STATE OF TENNESSEE DEPARTMENT OF TRANSPORTATION DESIGN DIVISION NASHVILLE, TENNESSEE 37243-0348

INSTRUCTIONAL BULLETIN NO. 13-1

Regarding New and Revised Standard Drawings

Effective immediately, the following Standard Drawings are new or revised and Section V of the Design Guidelines is revised for this update.

12-18-95 D-CB-12P

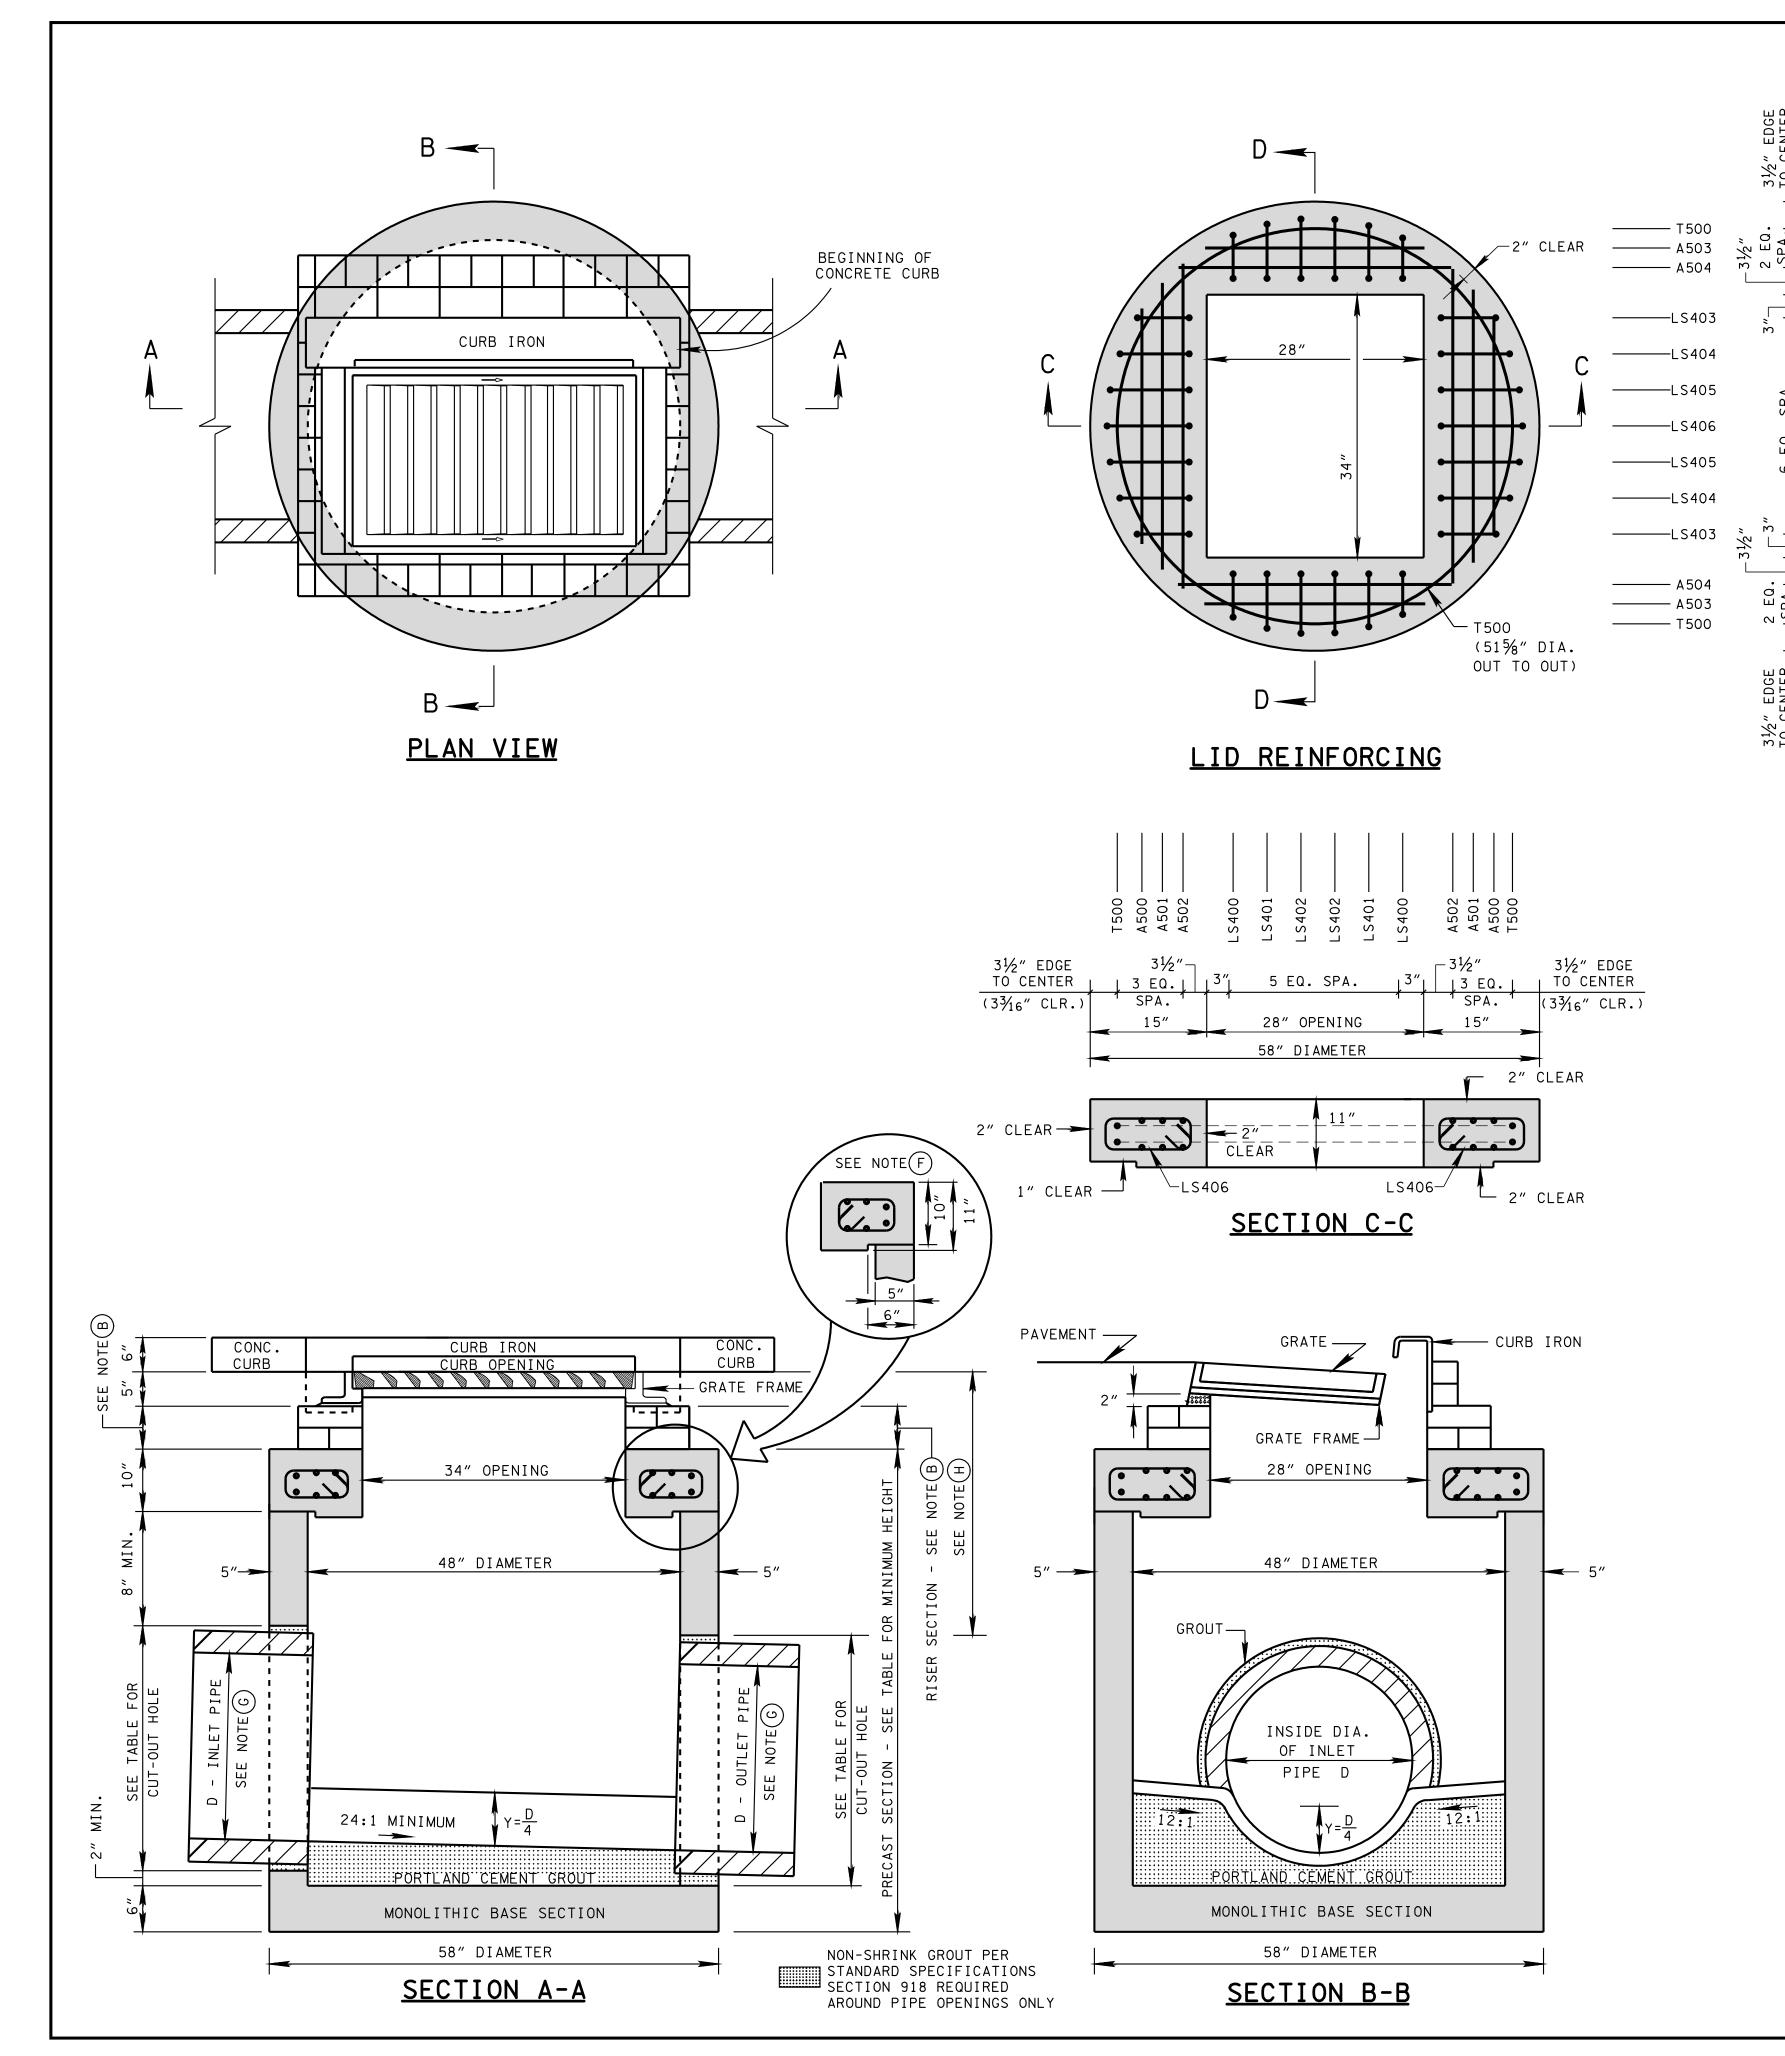
- ☐ REV. 10-26-97: CHANGED MINIMUM DEPTH TABLE AND MODIFIED STEEL IN BASE SECTION.
- ☐ REV. 1-19-99: MODIFIED CATCH BASIN MINIMUM DEPTH TABLE.
- ☐ REV. 5-27-01: CHANGED PAY ITEMS
- IN GENERAL NOTE (I)
- REV. 7-29-02: CHANGED ASTM SPECIFICATION IN GENERAL NOTE (B)

REV. 8-01-12: REVISED CATCH BASIN FOR COMPLIANCE WITH AASHTO LRFD BRIDGE DESIGN SPECIFICATIONS, 4TH EDITION WITH INTERIMS. REVISED REINFORCING, GENERAL NOTES, LEGEND AND ADDITIONAL MISC. DRAFTING FDITS

☐ REV. 9-24-12: MODIFIED TOP SLAB AND MINIMUM DEPTH.

5-27-95 | D-CB-12RA

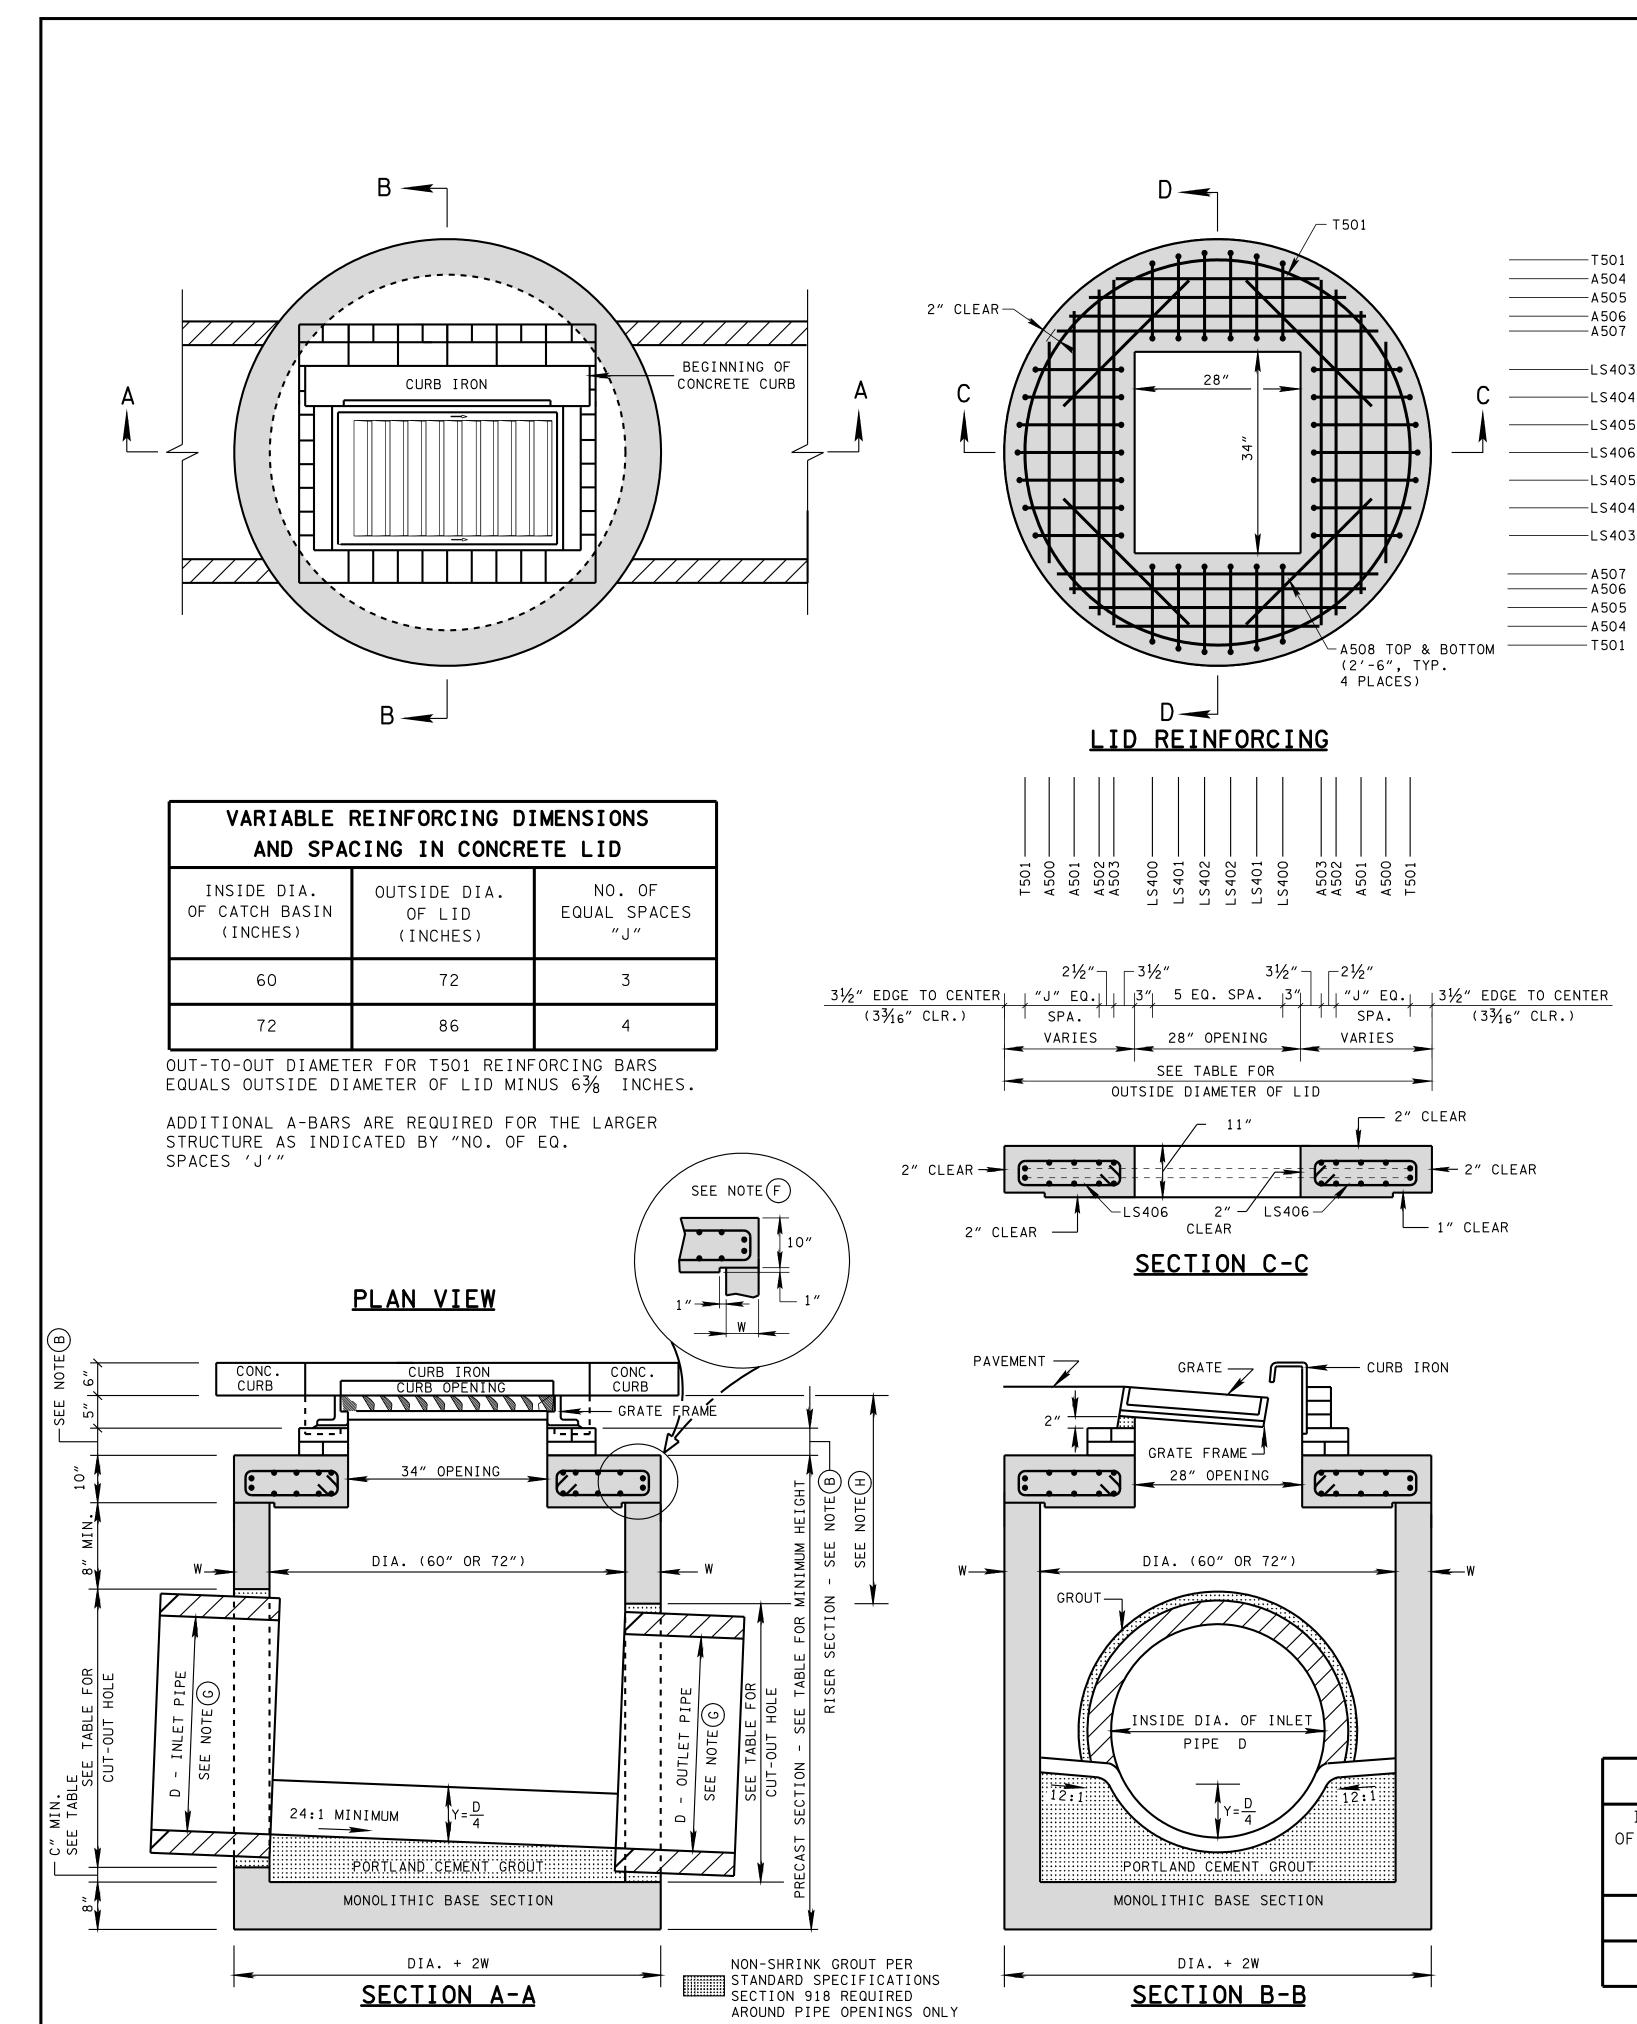
REV. 8-01-12: REVISED CATCH BASIN LID FOR COMPLIANCE WITH AASHTO LRFD BRIDGE DESIGN SPECIFICATIONS, 4TH EDITION WITH INTERIMS. REVISED REINFORCING, GENERAL NOTES AND ADDITIONAL MISC. DRAFTING EDITS.

REV. 9-24-12: MODIFIED TOP SLAB AND MINIMUM DEPTH.

4-15-00 D-CB-12RC

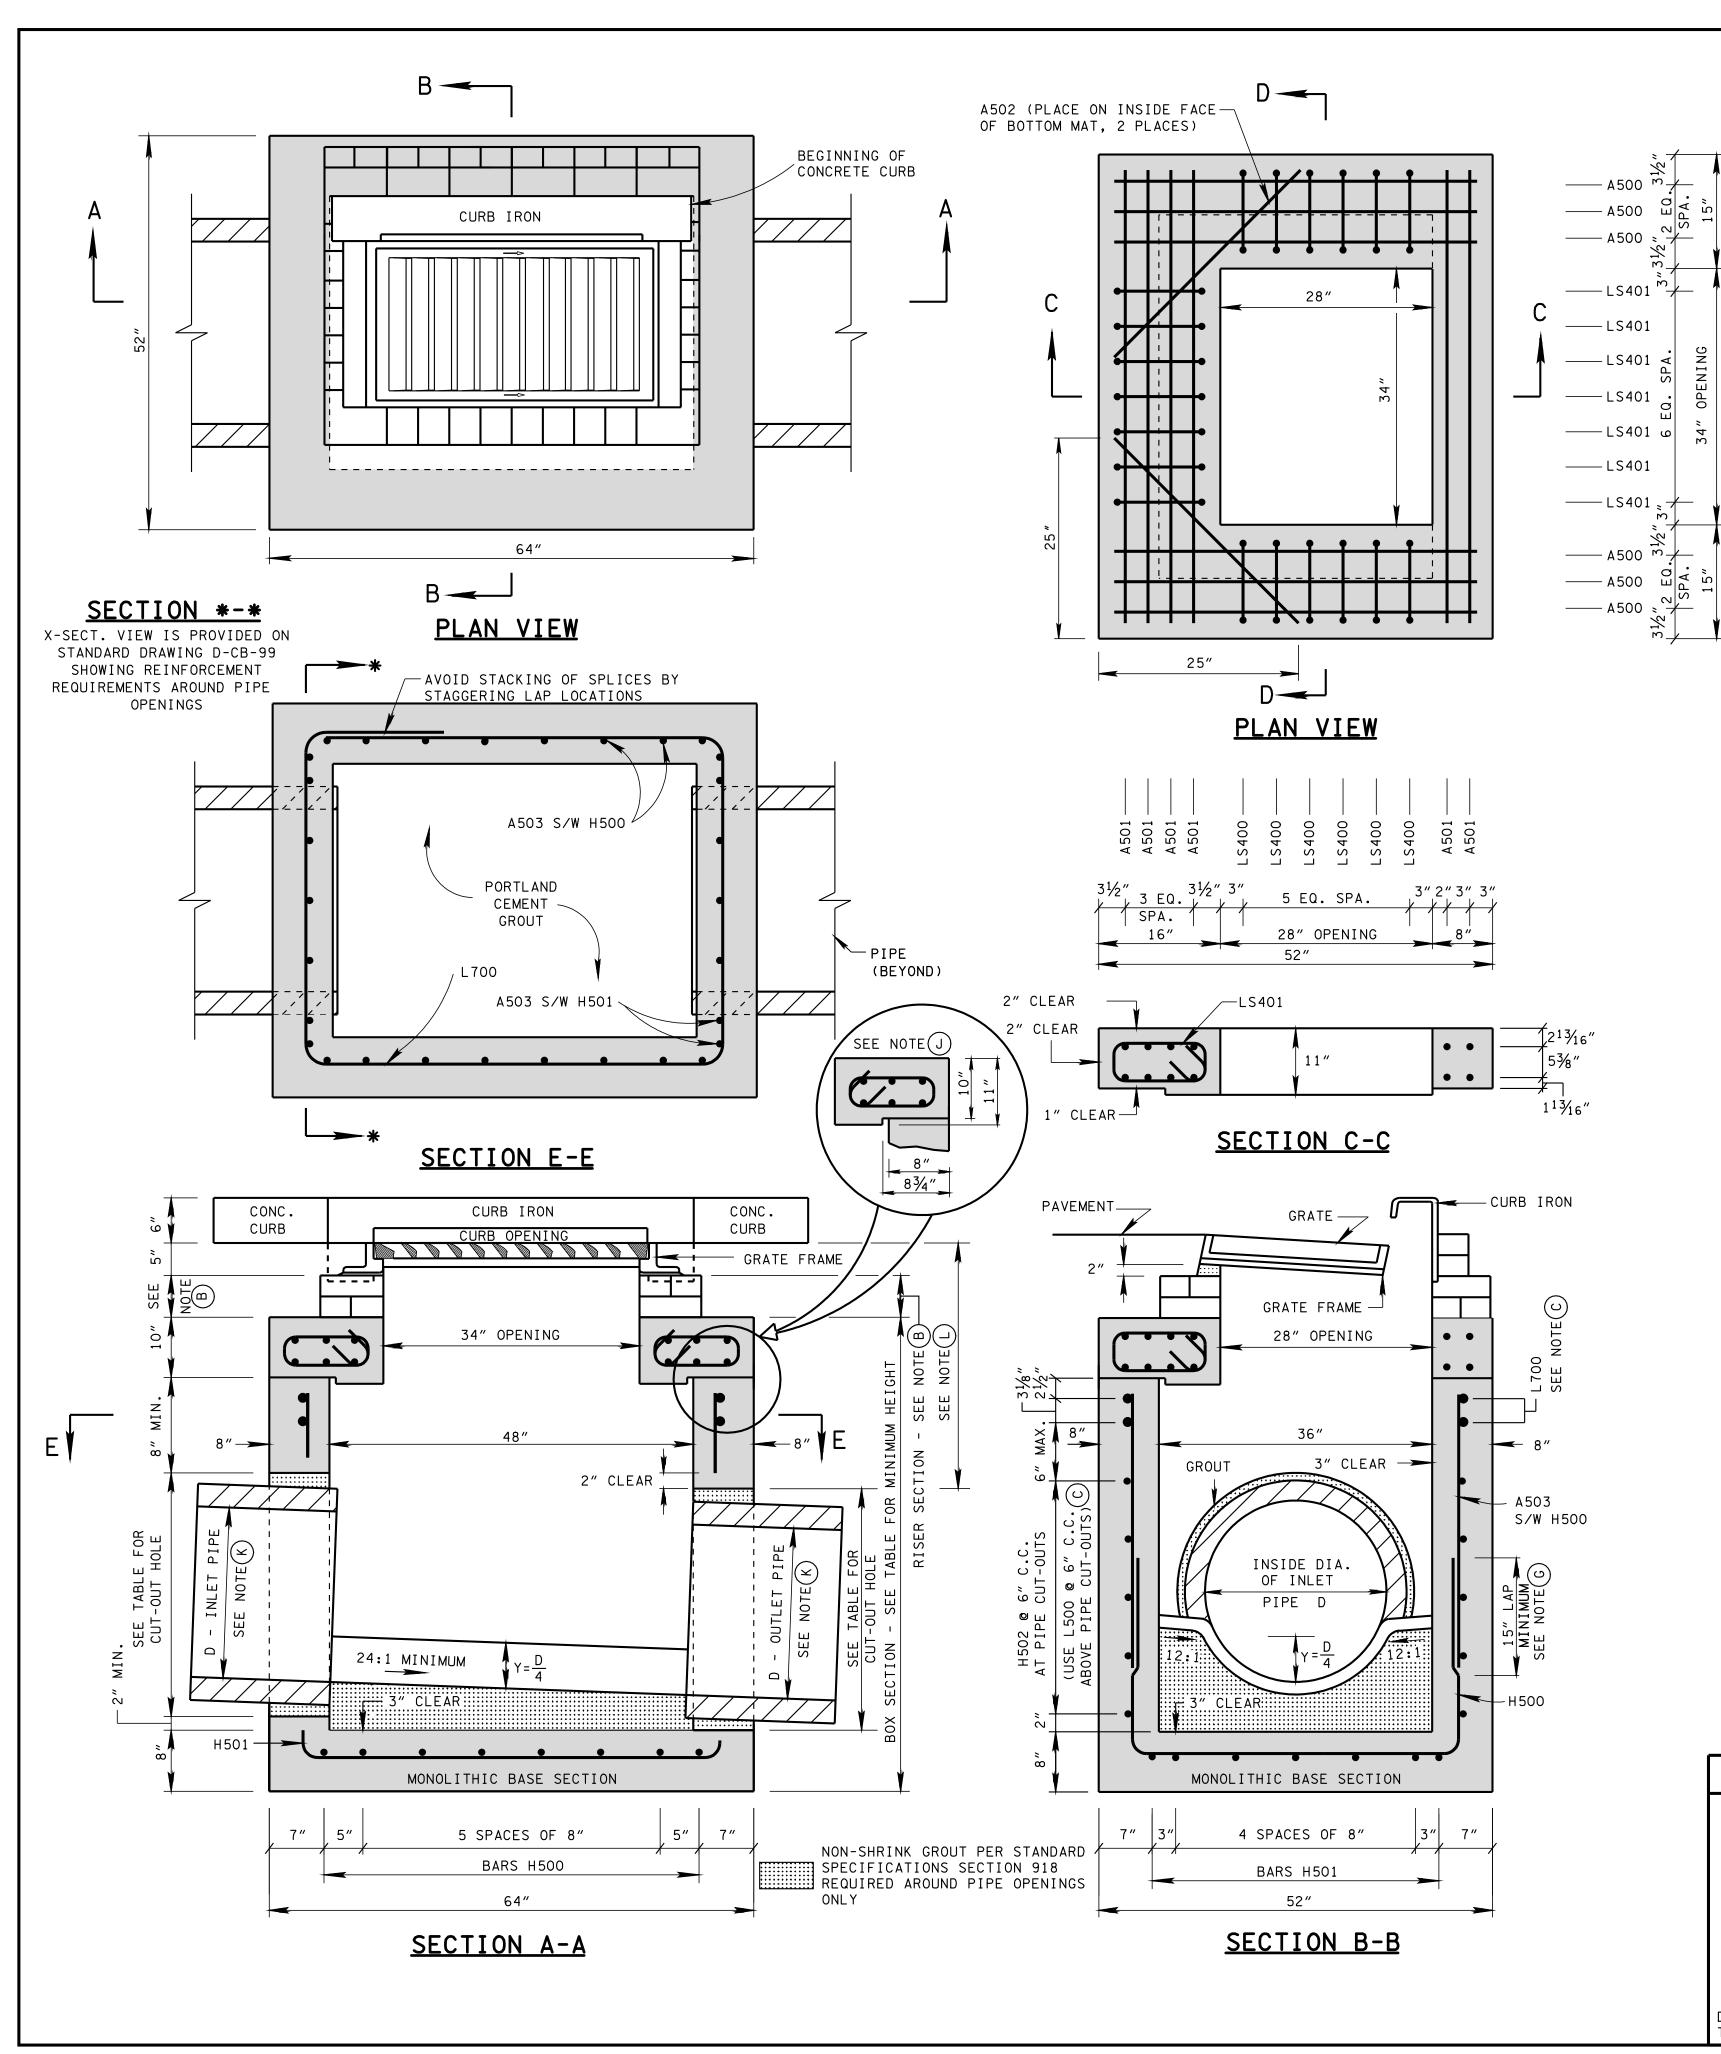
REV. 9-24-12: MODIFIED TOP SLAB AND MINIMUM DEPTH.

REV. 8-01-12: REVISED CATCH BASIN LID FOR COMPLIANCE WITH AASHTO LRFD BRIDGE DESIGN SPECIFICATIONS, 4TH EDITION WITH INTERIMS. REVISED REINFORCING,
